# Product Change Notification

## 112291 - 00

**Change Notification #:** 112291 - 00  
**Change Title:** Intel® Server System P4308CP4MHGC  
PCN 112291-00, Product Design, Label,  
Update BIOS/ME Firmware and Package  
Regulatory Label with Perchlorate Statement  
**Date of Publication:** May 20, 2013

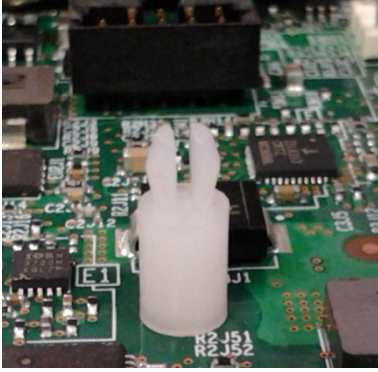
3. A plastic stand-off will be pre-installed on the server board. Users can install an eUSB SSD device on the stand-off.

The picture below shows the stand-off pre-installed on the server board:
